PROJECT NAME: STERLING HALL SCHOOL – PHASE 1 MASTER PLAN ADDITION

PROJECT No.: 00036-010-E-001

DATE: 2026-07-22

ADDENDUM No.: E01

scale: N.T.S.  
date: XX/XX/2X  
drawn: RLJG  
checked by: Checker  
project number: 00036.010.E001  
drawing number: E-201  
Revision: 8

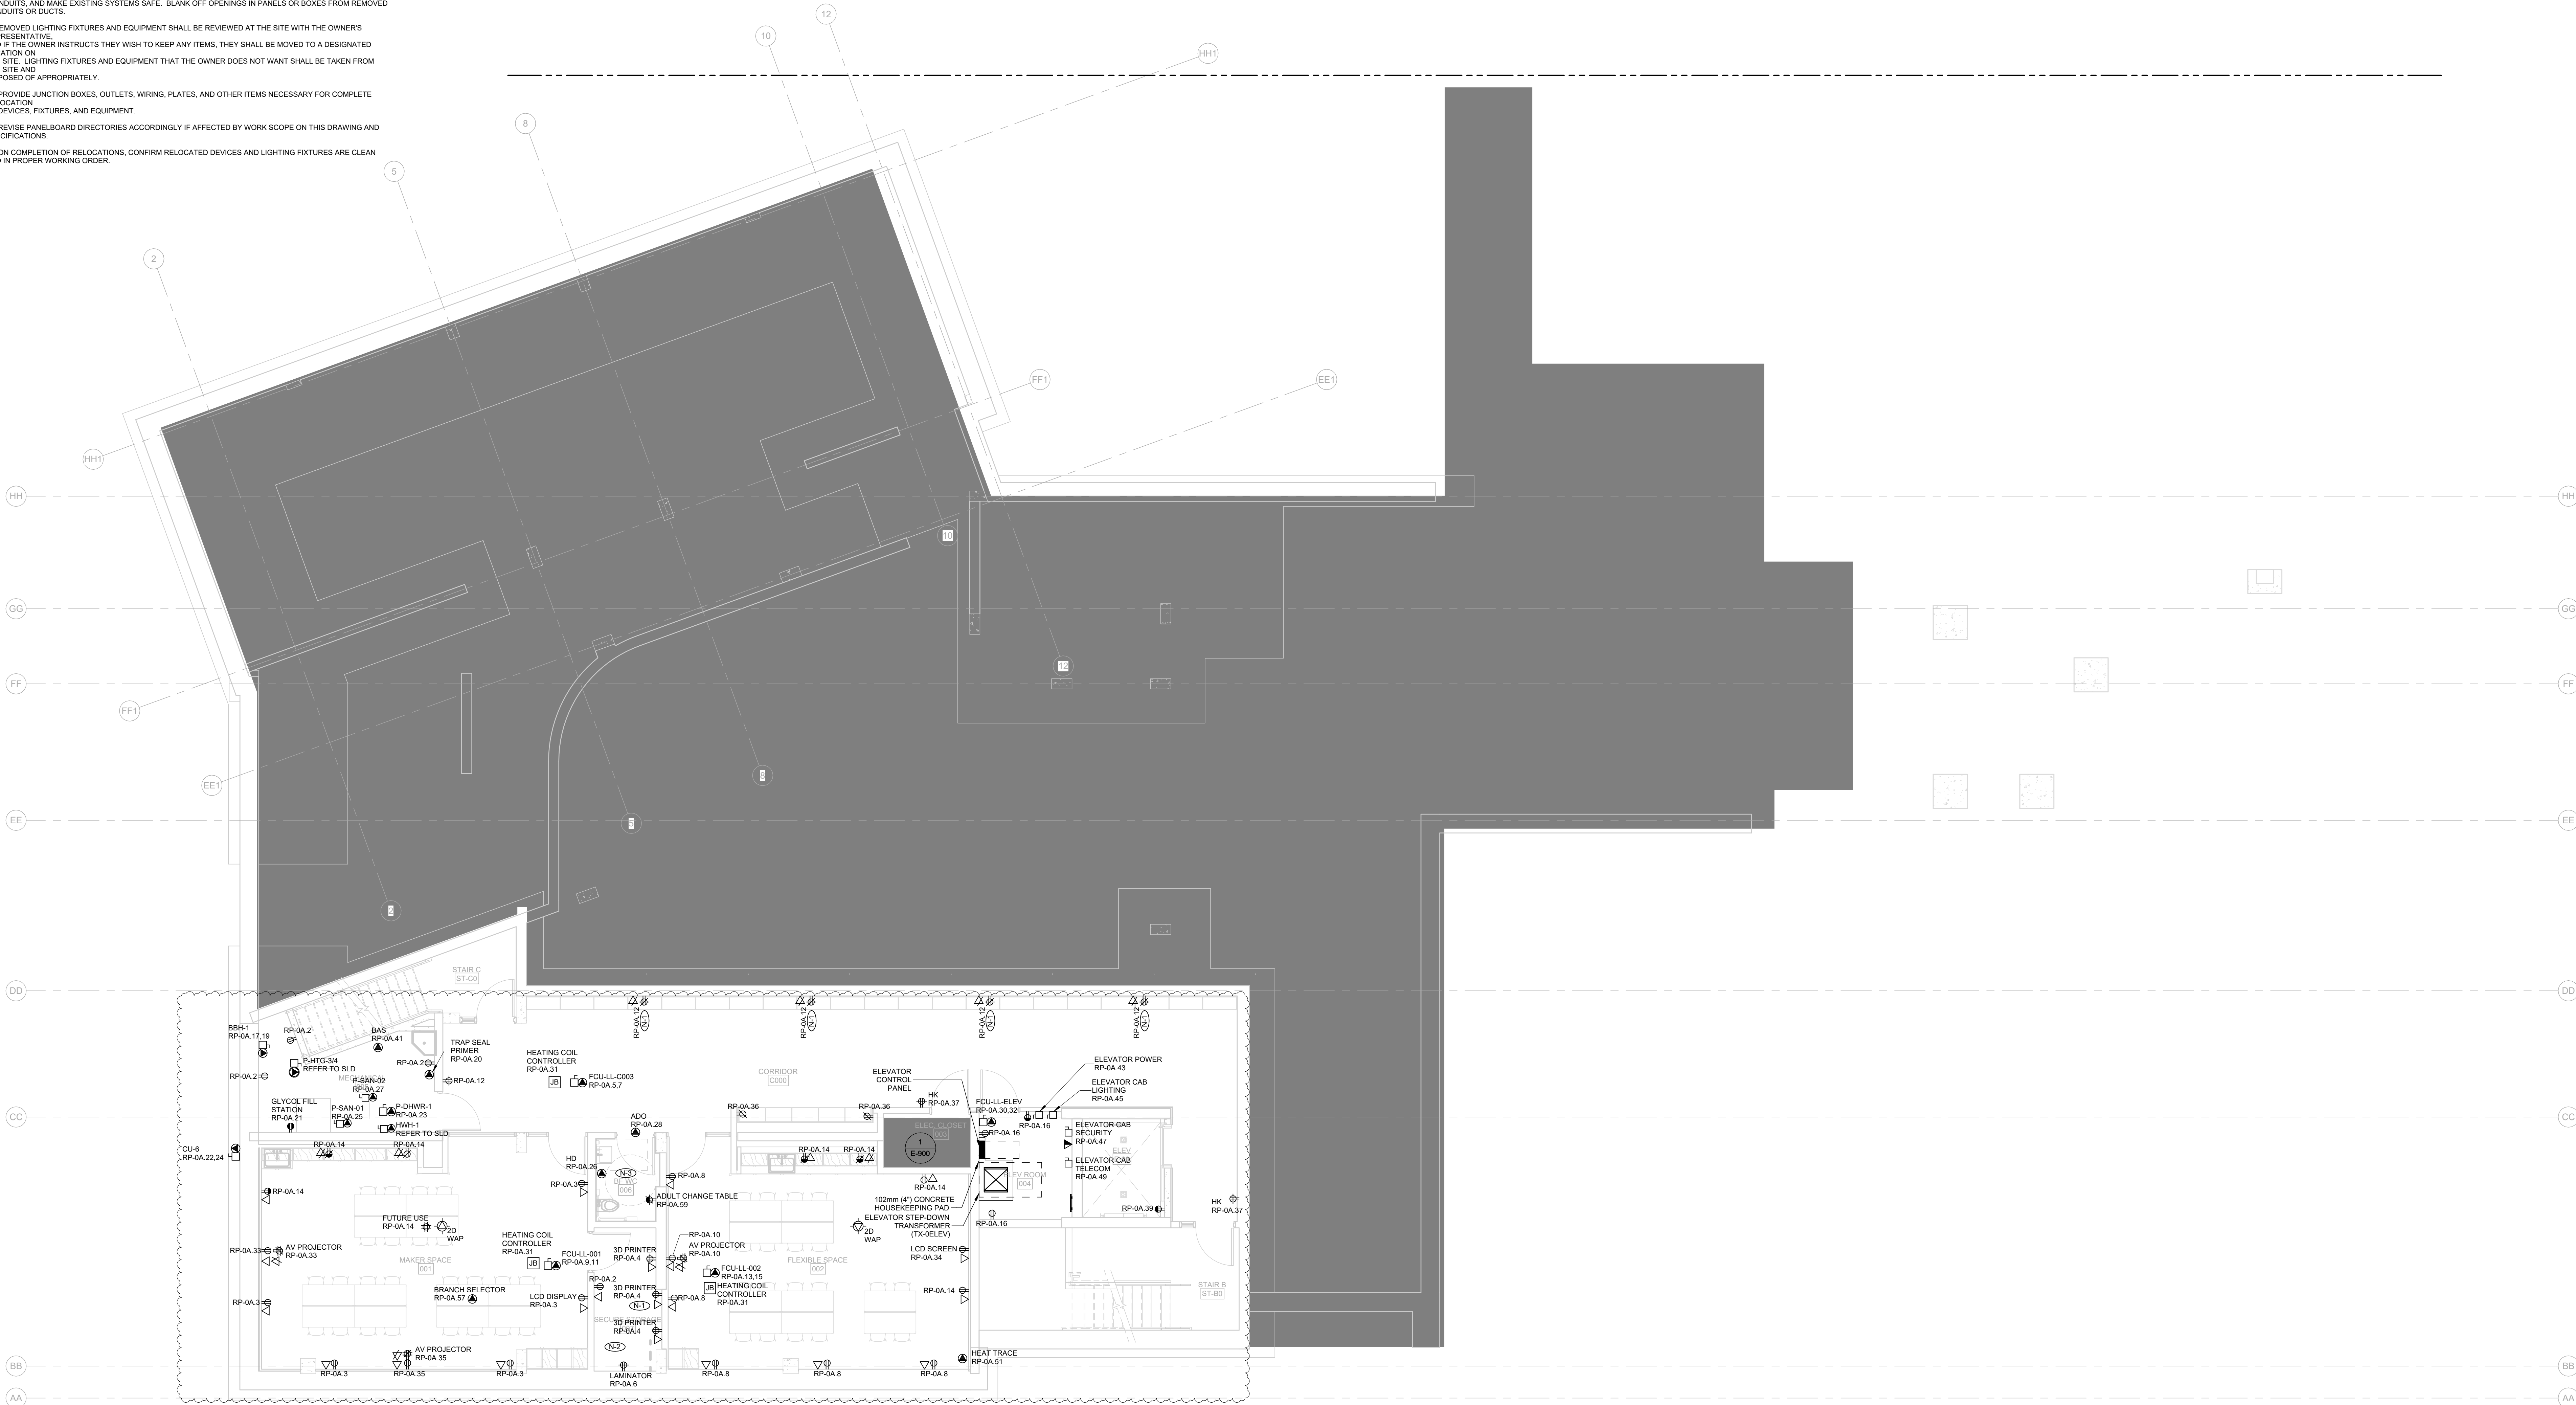
- 2.1.6 E-200: Revise electrical distribution equipment and feeders.
- 2.1.7 E-201: Add fire alarm DGP and revise fire alarm riser. Security riser clarifications.

scale: 1 : 75  
date: XX/XX/2X  
drawn: RLJG  
checked by: Checker  
project number: 00036.010.E001  
drawing number: **E-400**  
Revision: 8

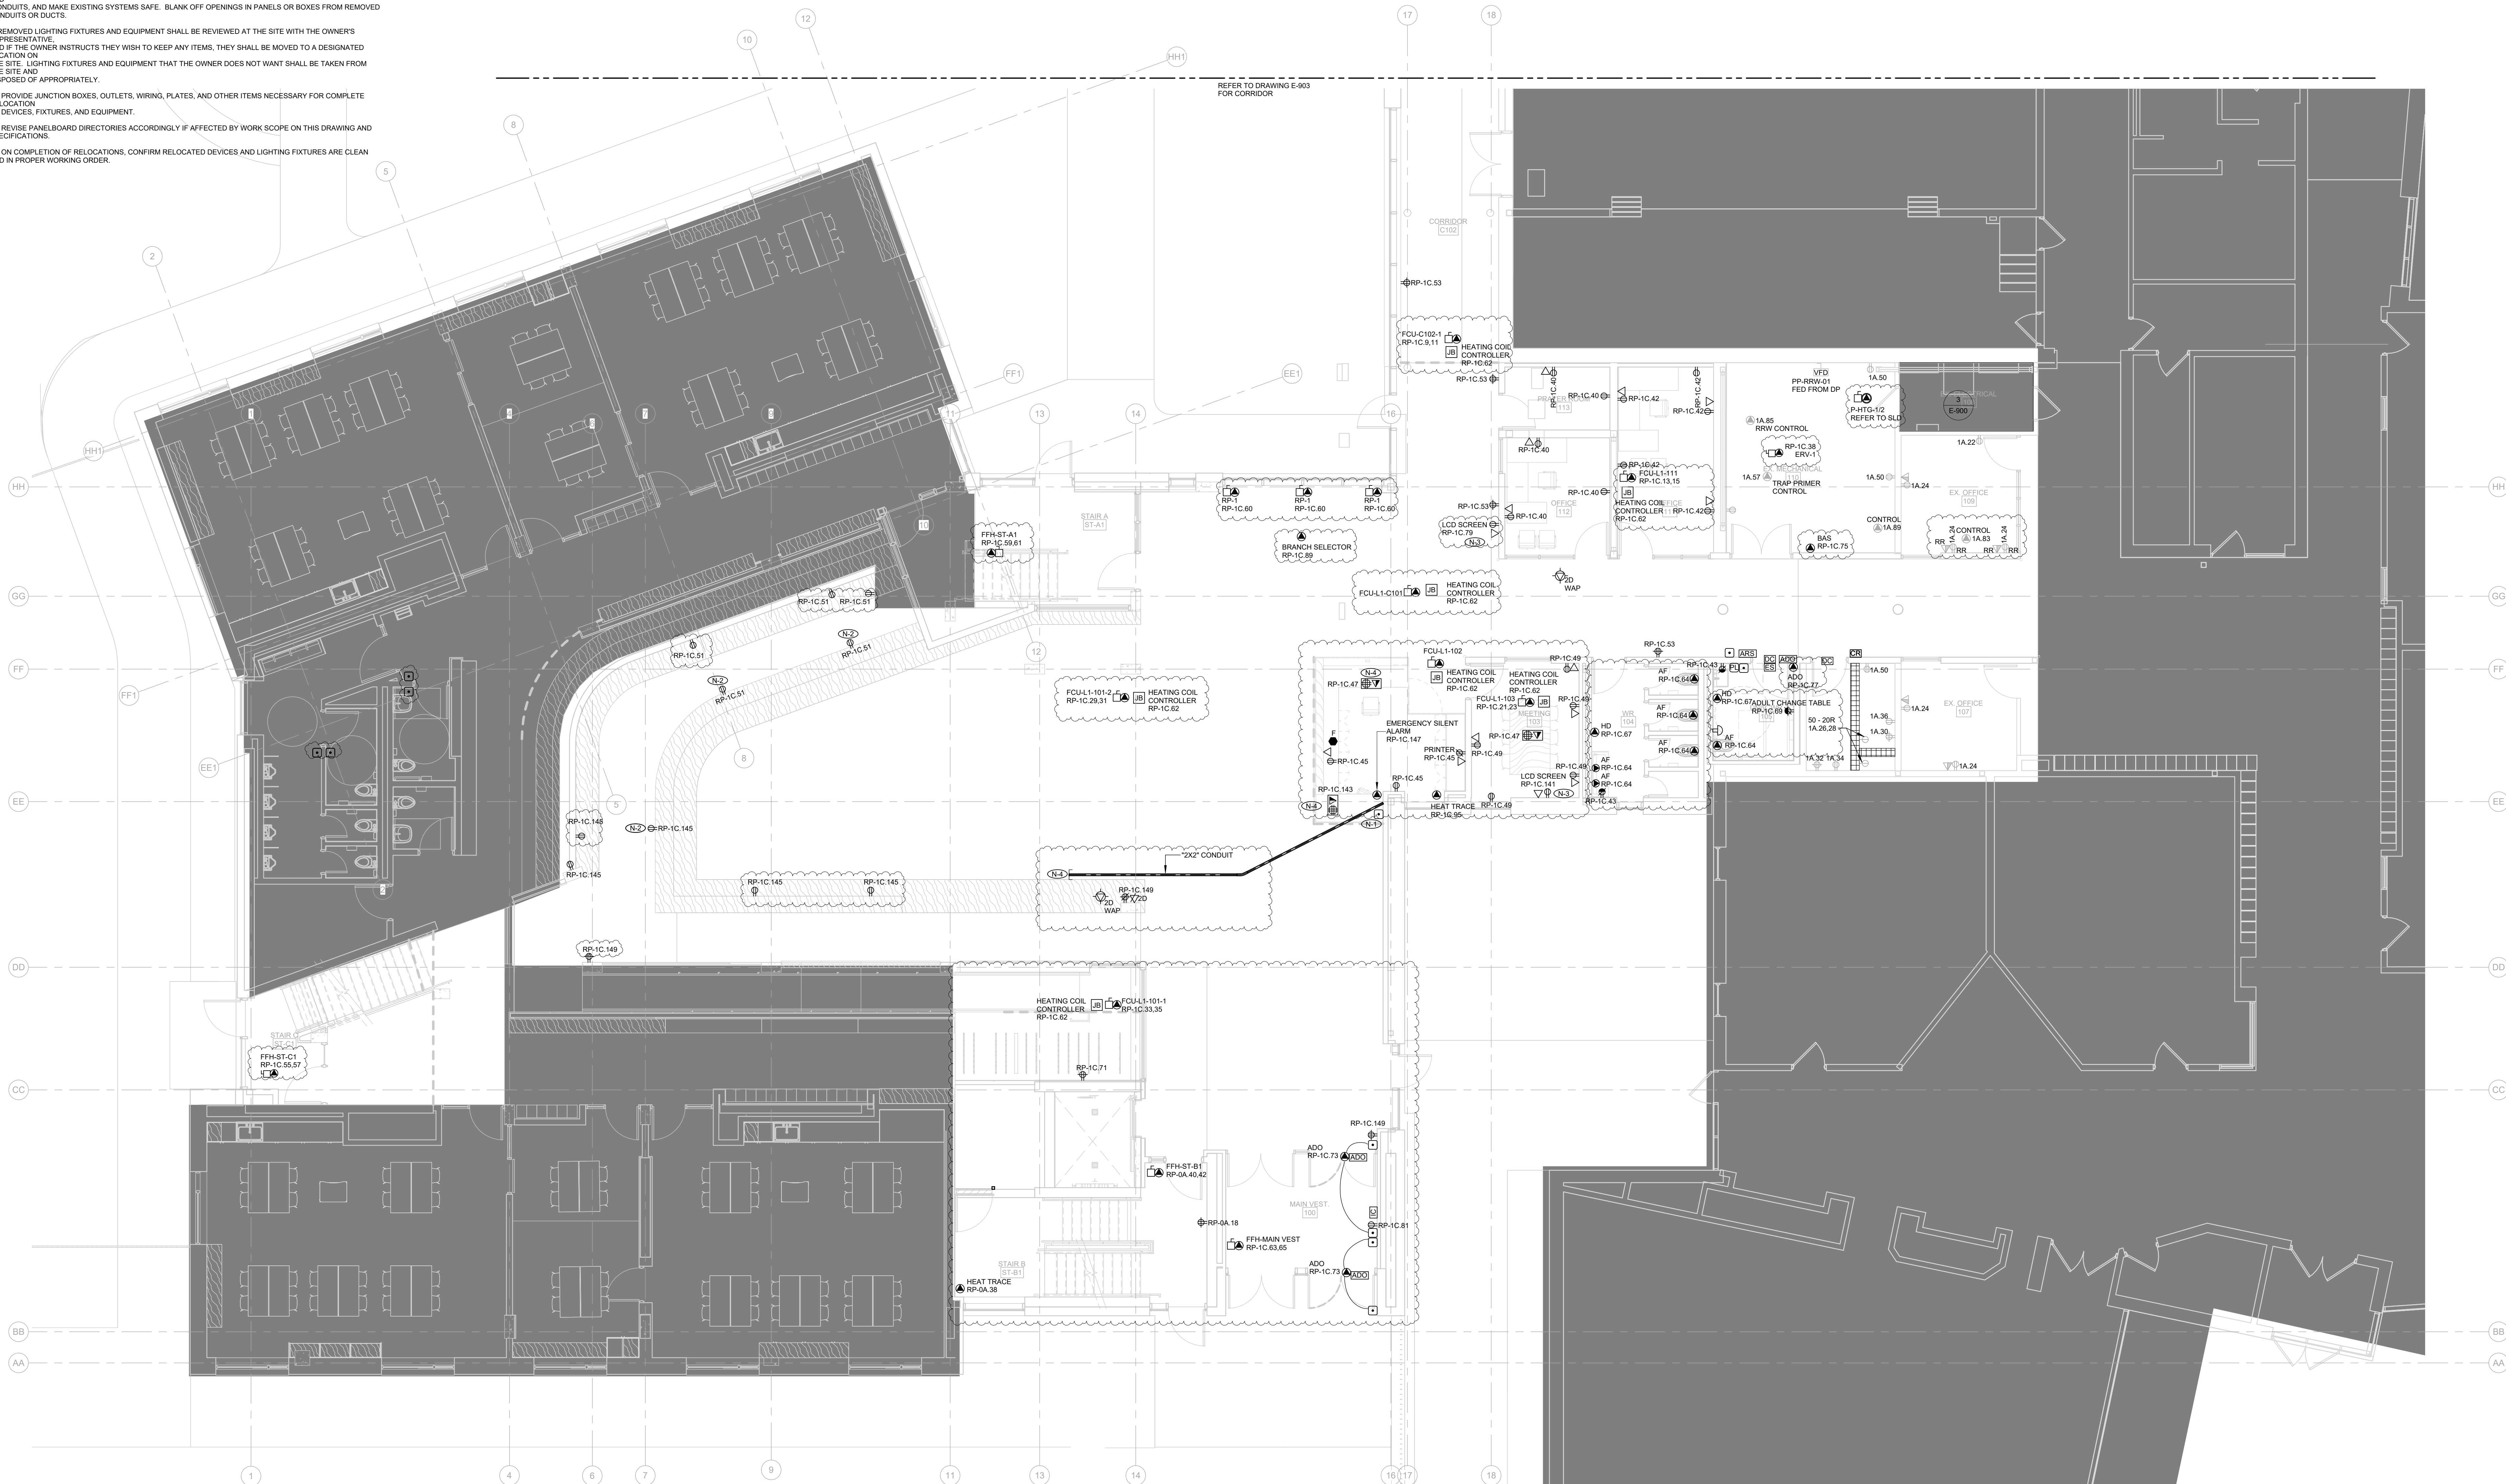
- 2.1.8 E-400: Revise power and communication layouts. Add electrical and data outlets and circuits.
- 2.1.9 E-401: Revise power and communication layouts. Add electrical and data outlets and circuits.

scale: 1 : 75  
date: XX/XX/2X  
drawn: RLJG  
checked by: Checker  
project number: 00036.010.E001  
drawing number: E-401.5  
Revision: 8

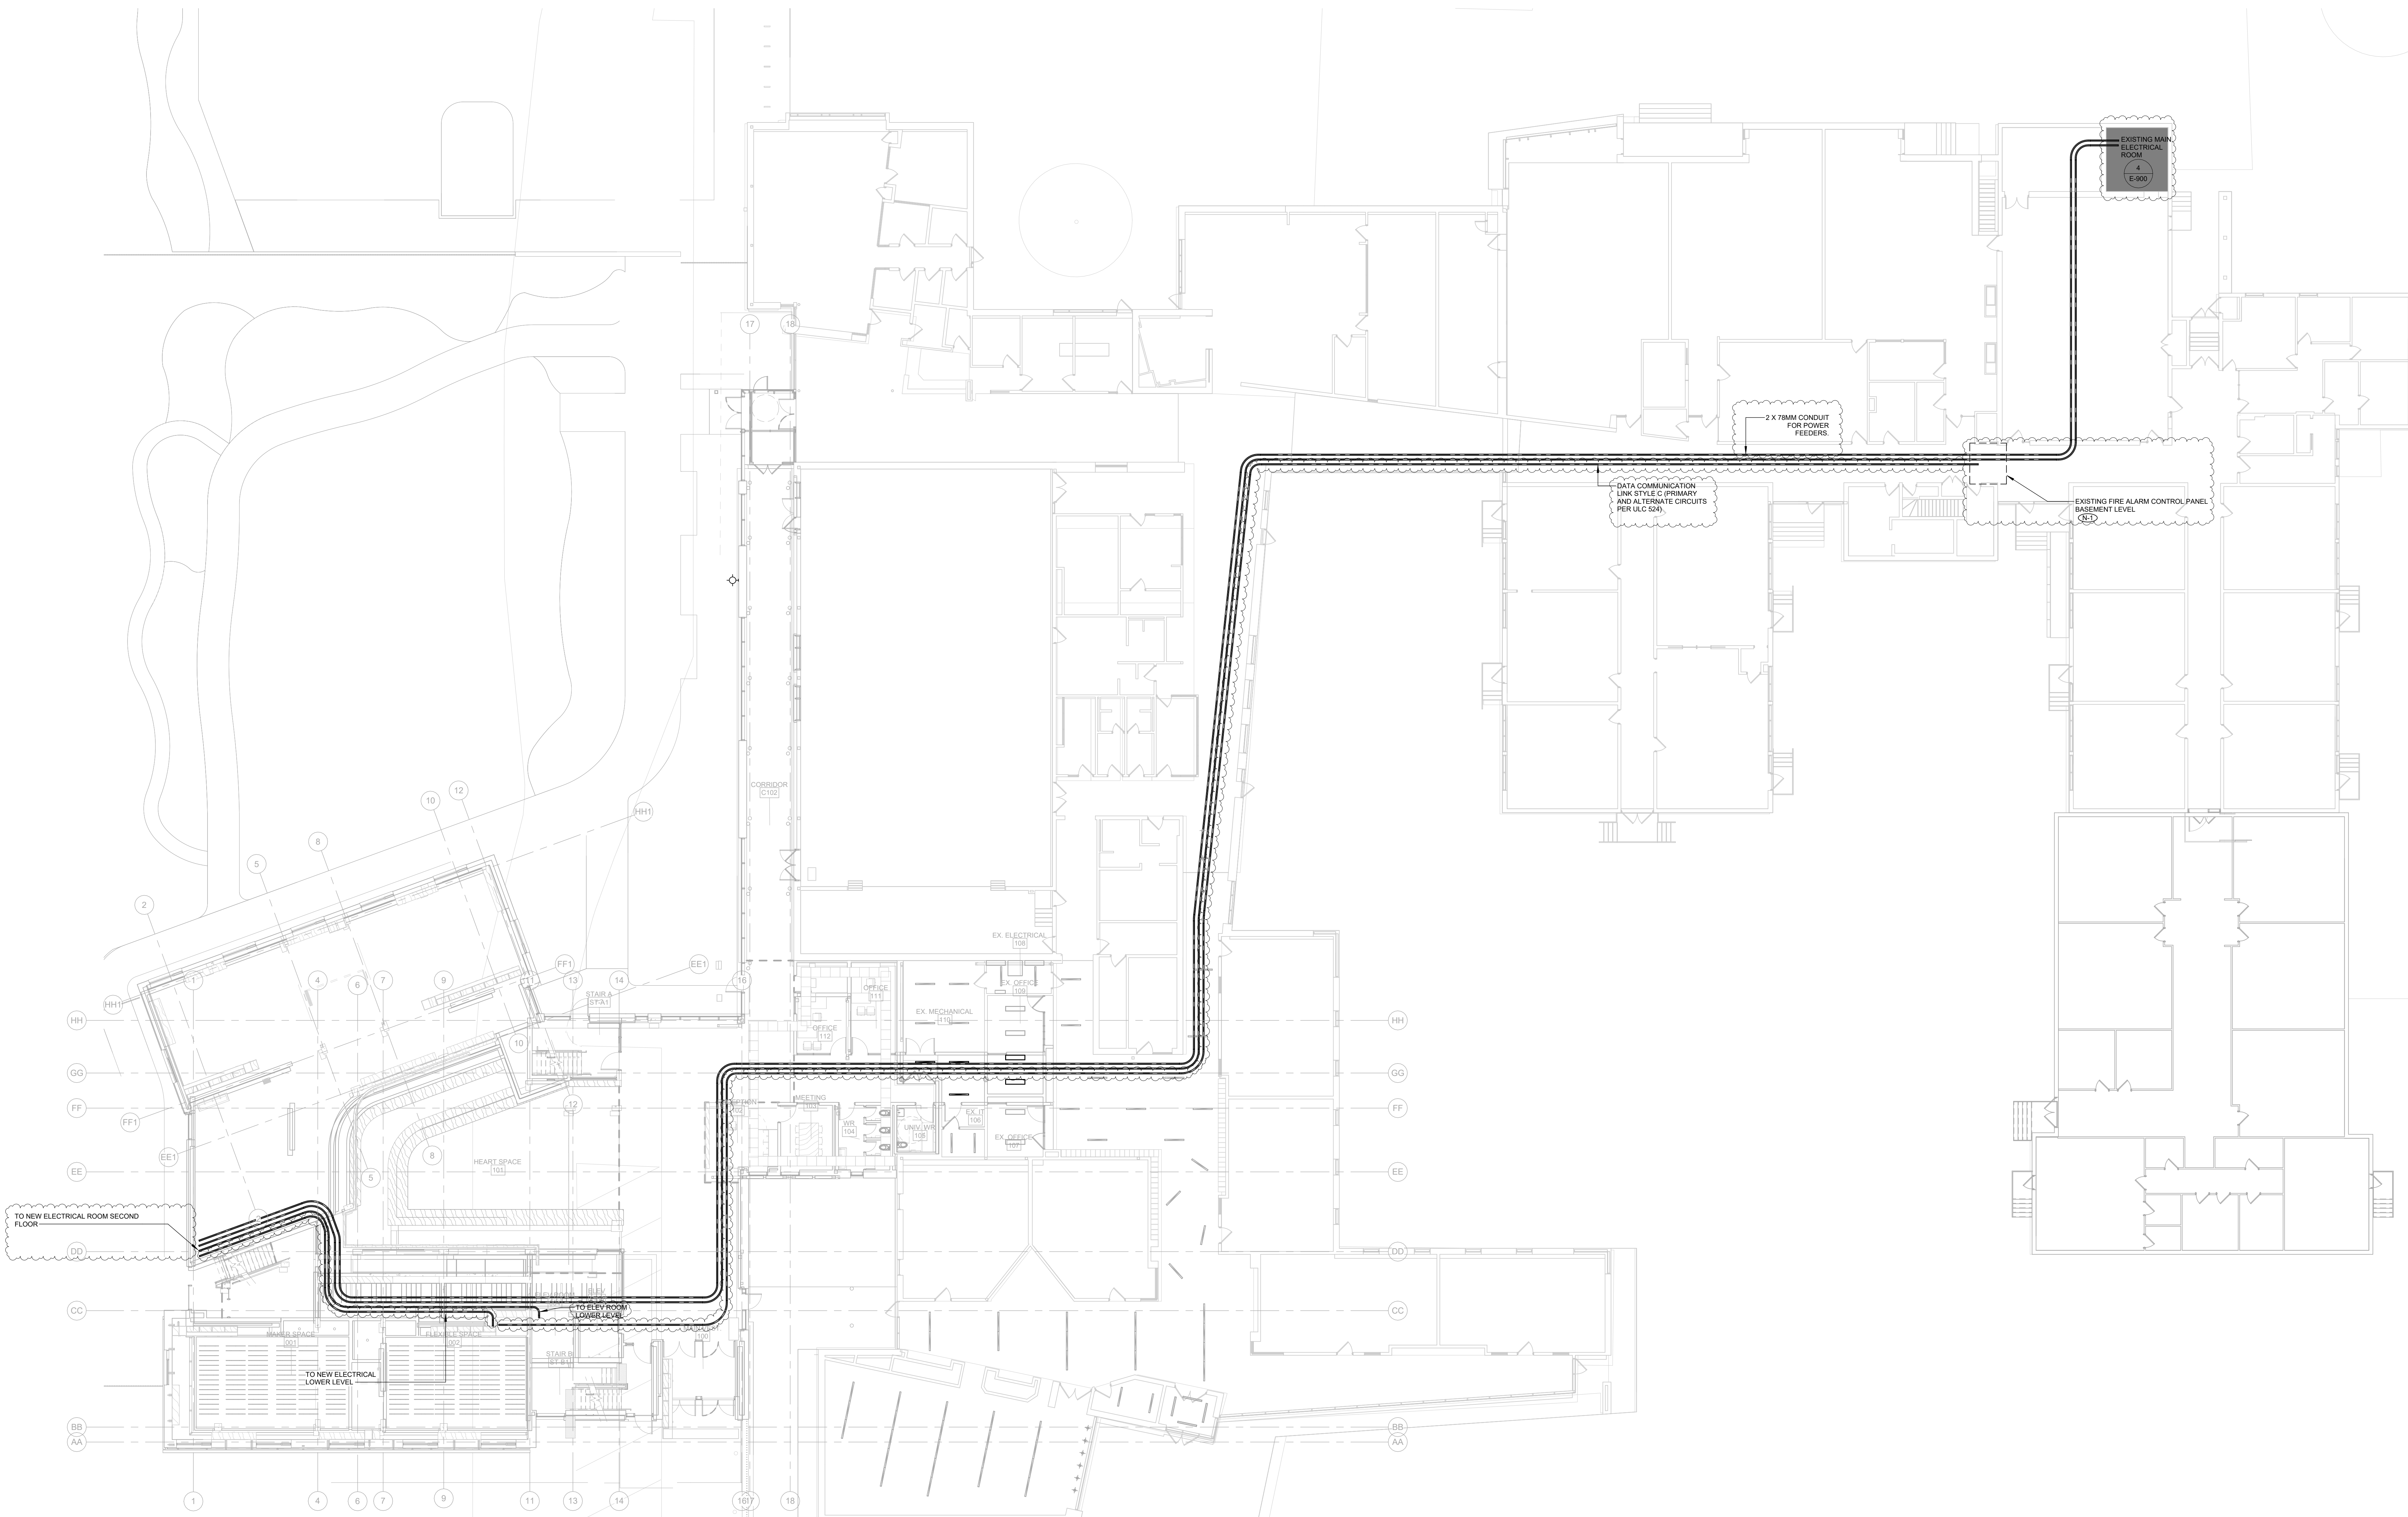
- 2.1.10 E-401.5: Revise power and communication layouts. Add electrical and data outlets and circuits.
- 2.1.11 E-401A: Clarifications regarding electrical services connecting addition and existing building.
